Plan Change Request

Site Address/ Parcel #: 1023 39TH AVE SE Permit #: PRCCP20240183
Owner: Benaroya Capital Email: davev@benaroya.com
Design Engineer: Cara Visintainer Email: cvisintainer@barghausen.com
Contractor: Howard S Wright Email: jlane@HSWC.com

➤ Specify the approved civil plans affected: C1, C6, C7, C11, C14, C15, C17, C19, C20

COVER SHEET
FOR
CENTERIS VOLTAGE PARK

SOUTH GRADING & DRAINAGE PLAN
FOR

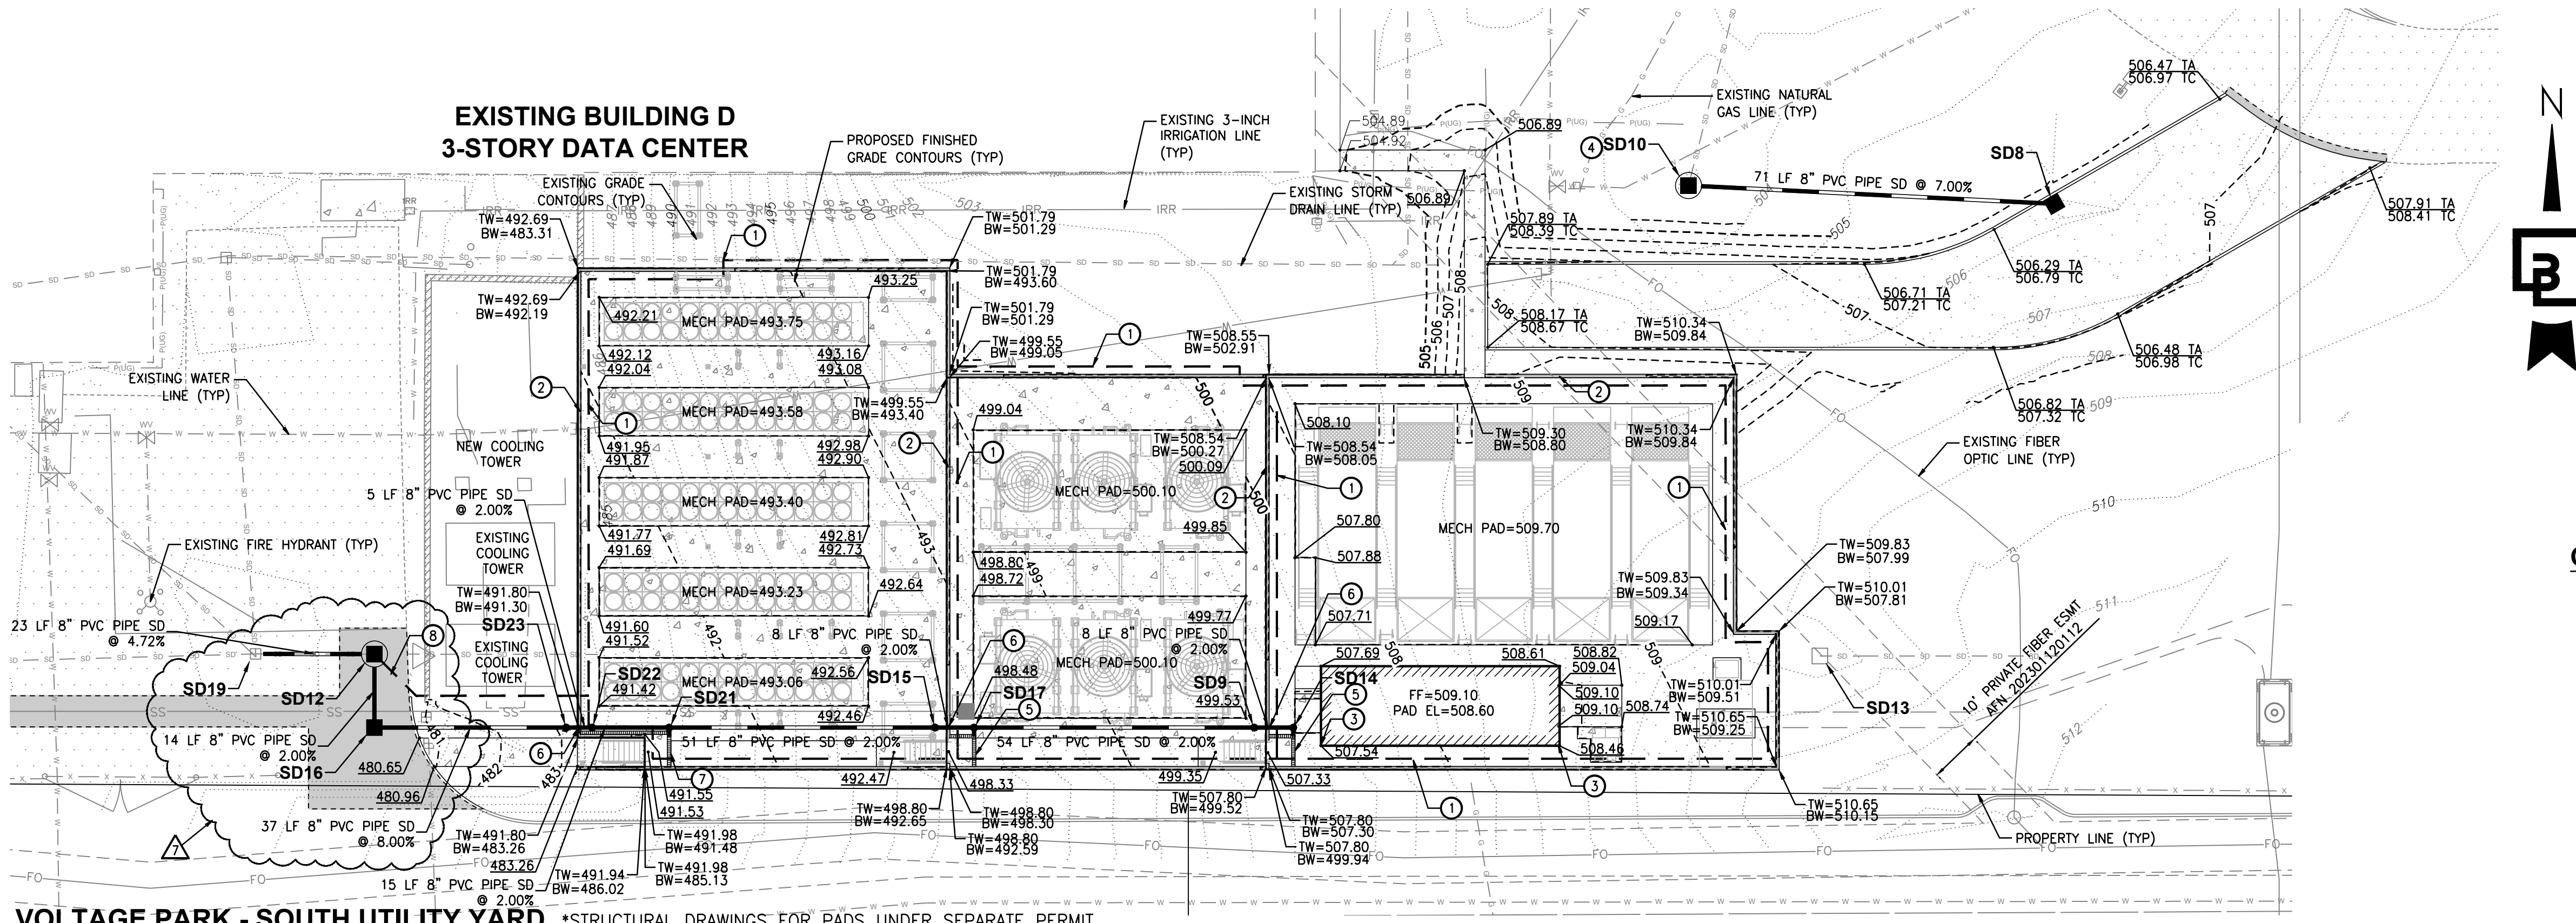
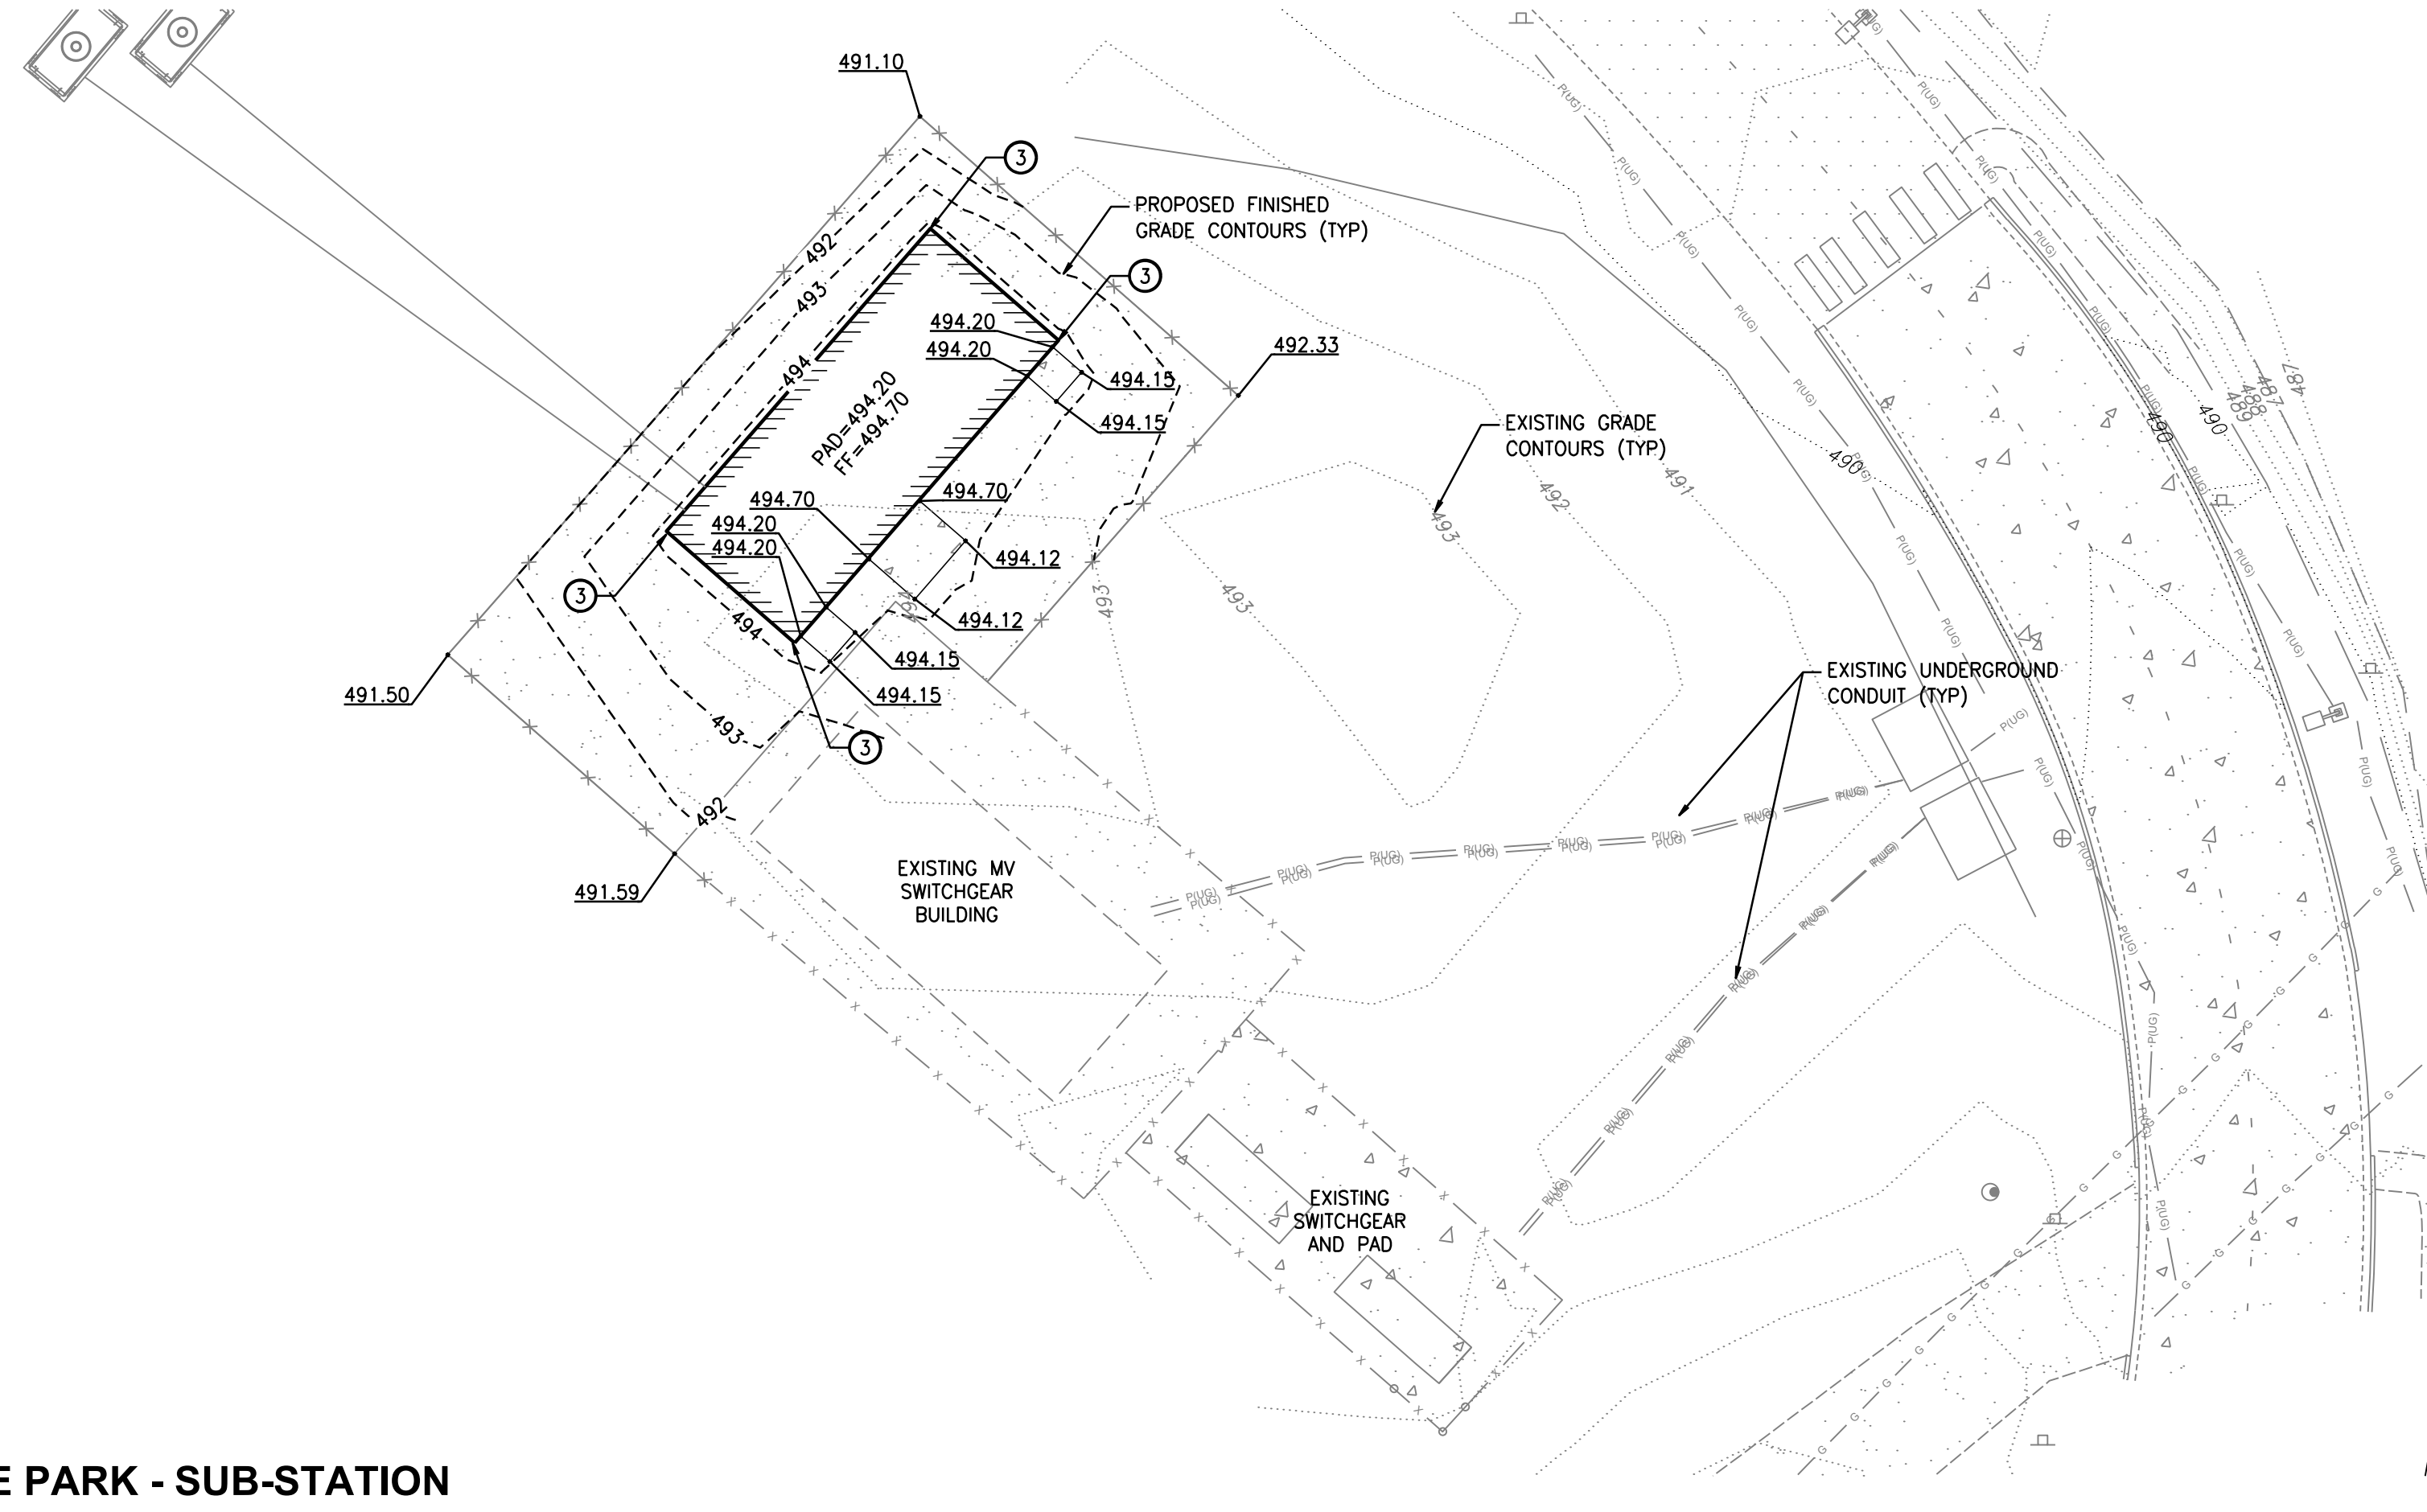
Additional utility yard footprint for the south utility yard that includes 5 new air cooled chillers and associated pumps, 1 new load bank, and 5 new standby diesel generators with above ground storage tanks. Water, sewer, and storm routes have been updated accordingly to accommodate the larger area of concrete paving and wall construction.

The stormwater pond had been revised to account for an additional foot of live storage that was already designed into the pond. The retaining wall has been reduced in height with adjusted clearing limits to account for additional grading above the proposed retaining wall.

Job Number	18111	Sheet	C18	22
------------	-------	-------	-----	----

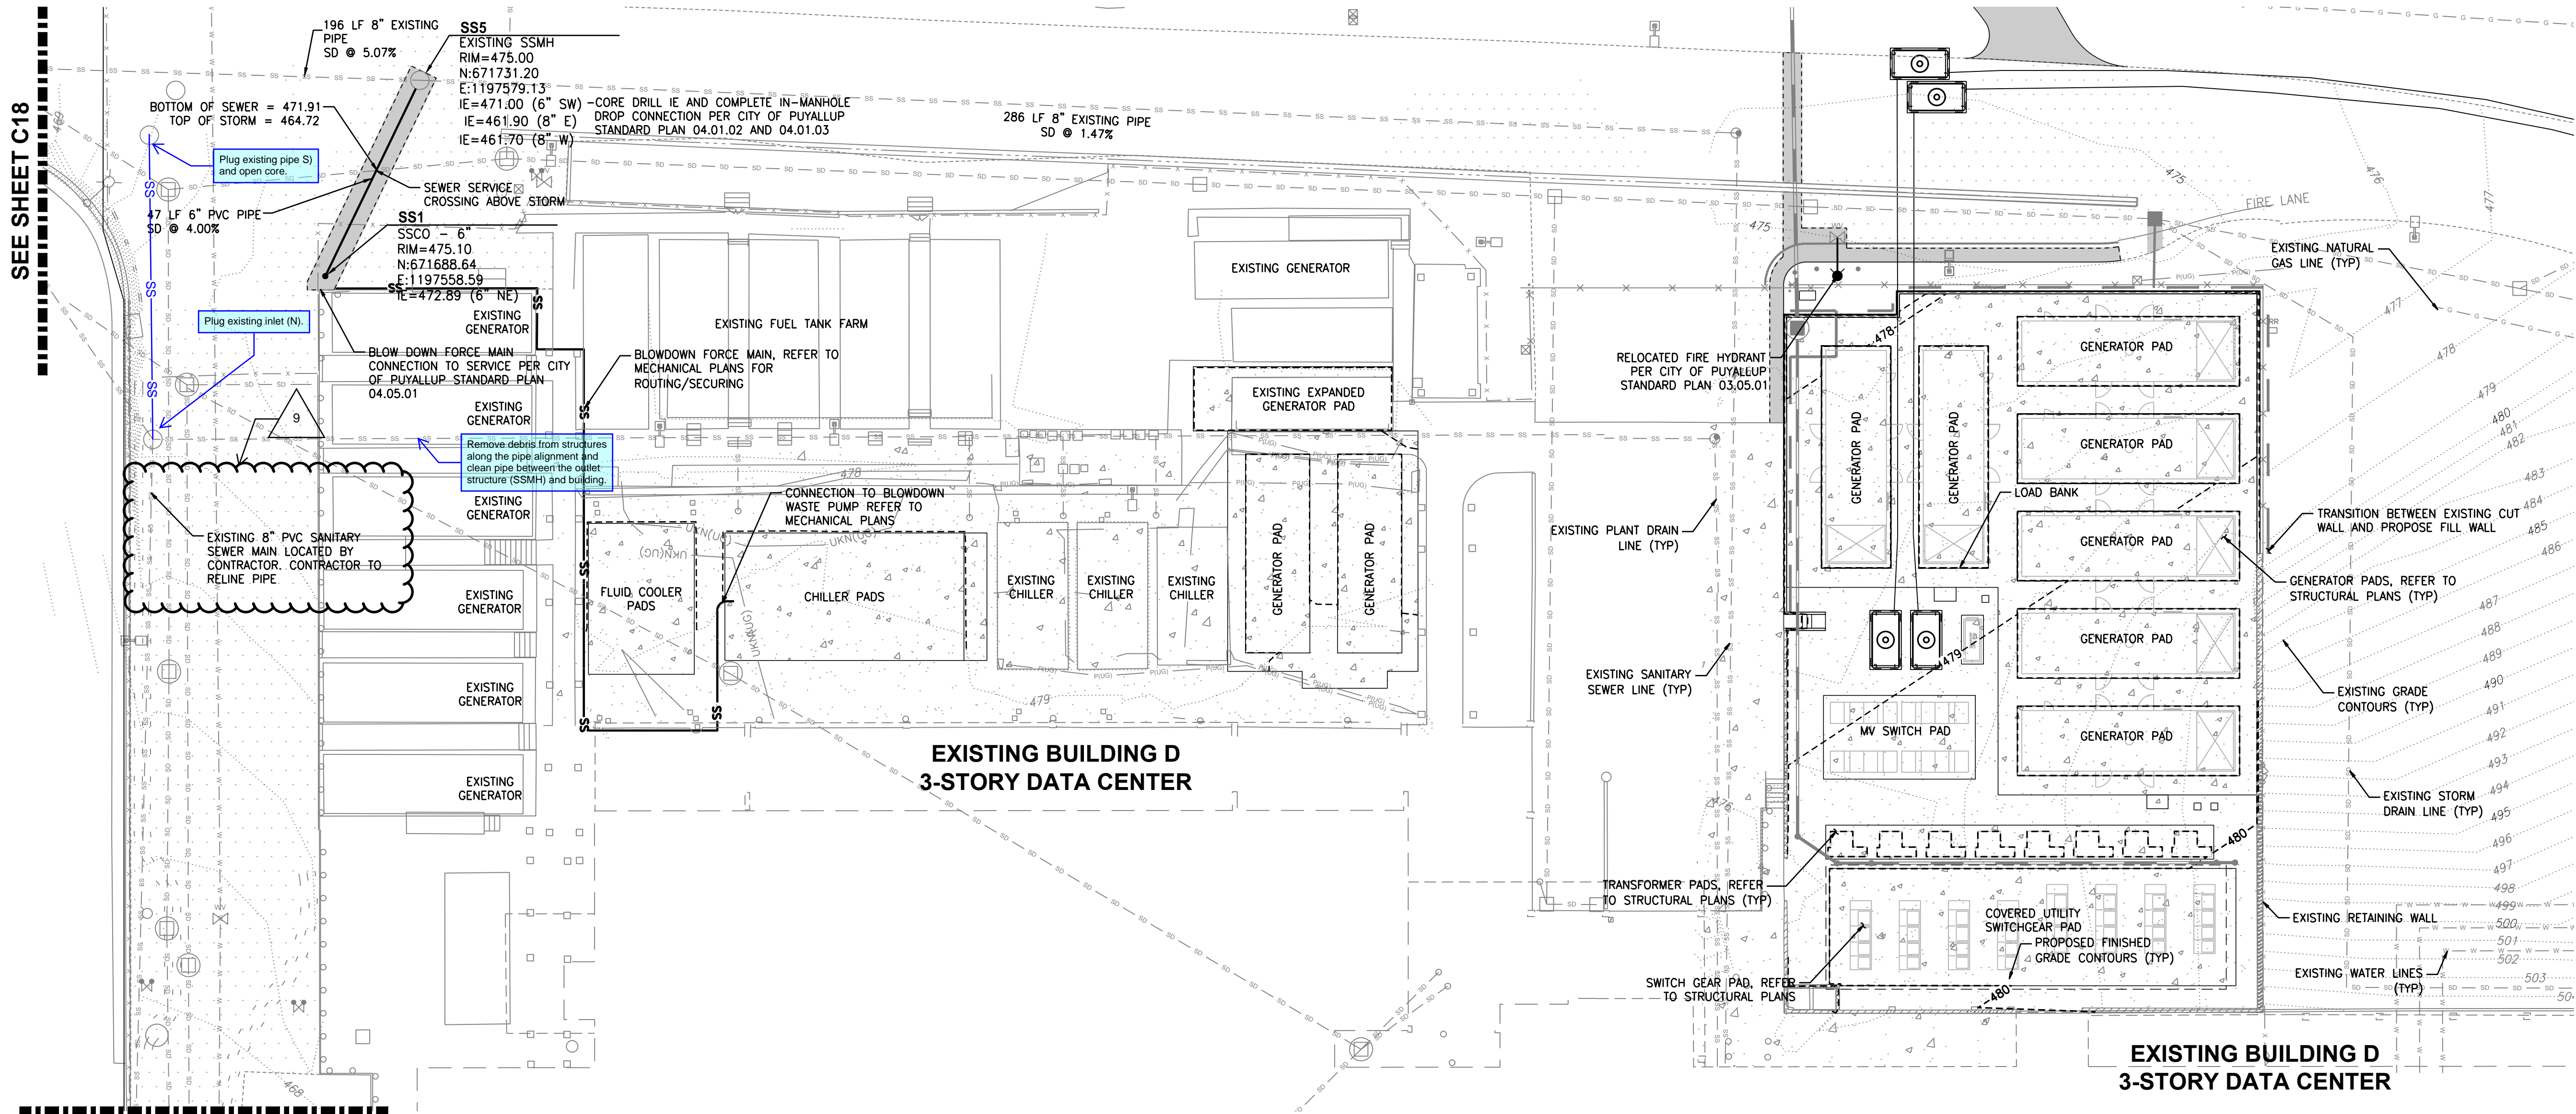
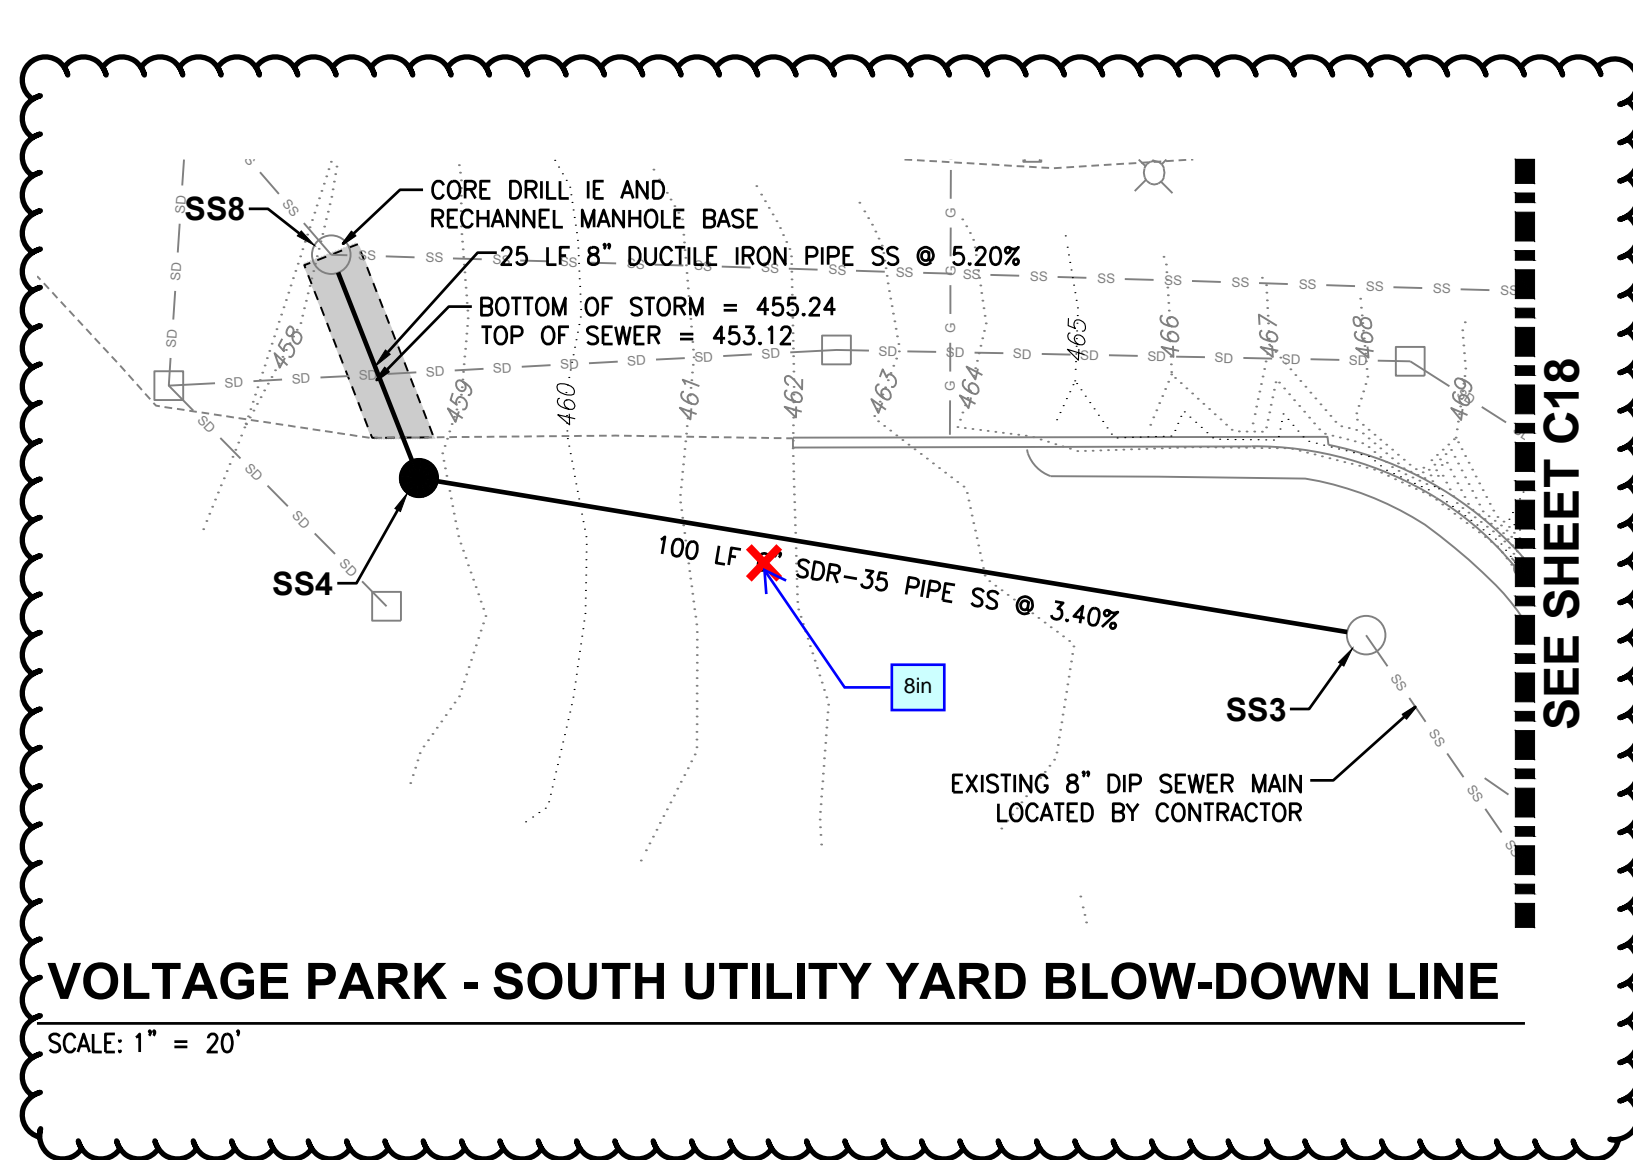
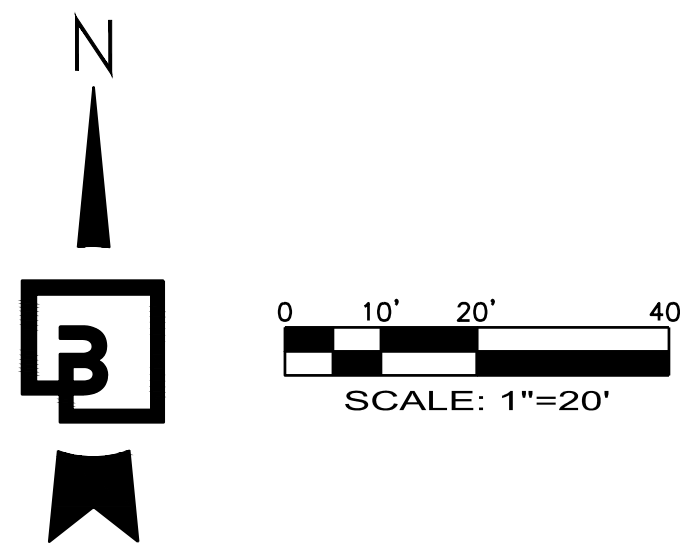
***SEE COMMENTS ON SHEET C18 and C20.

8in
(Per CVisintainer
email dated 12-18-24)
